KAFB 93
State of New Mexico
ENVIRONMENT DEPARTMENT
Harold Runnels Building
1190 St. Francis Drive, P.O. Box 26110
Santa Fe, New Mexico 87502
(505) 827-2850

MEMORANDUM

SUBJECT: **Review of Data and Regulatory Requirements Related to Groundwater Monitoring at the Sewage Lagoons and Golf Course Main Pond, Kirtland Air Force Base, Albuquerque**

Water-table contour map of the sewage lagoons area.

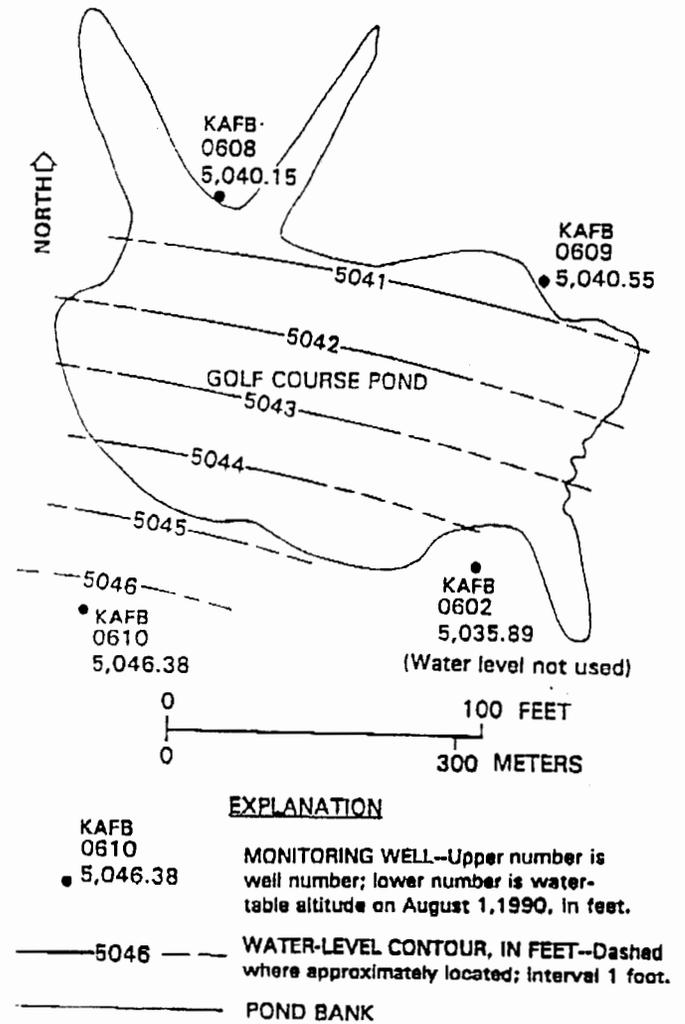
Monitoring wells at the SL's and GCMP are shown on the attached figure. Screen length of all MW's is twenty feet. At the SL's, MW-0504 may be considered as an upgradient well. MW-0501 is a side-gradient well; MW's 0502 and 0503 are downgradient wells. At the GCMP, MW-0610 appears to be an upgradient well, but the water level in the well is approximately 25 feet above the top of the screen. MW-0602 is a side-gradient well; the water level in the well is approximately 110 feet above the top of the screened interval. MW's 0608 and 0609 are also side-gradient wells.

The MW's at the SL's and GCMP do not meet strict regulatory requirements [one hydraulically upgradient and three downgradient MW's at a site; 40 CFR 265.91(a)]. The USGS report indicates, however, because of the proximity of the MW's to the units and the "great" depth to groundwater (480 feet at the SL's; 320 feet at the GCMP), the MW's are located "adequately" to detect water infiltrating from the SL's and GCMP to the groundwater.
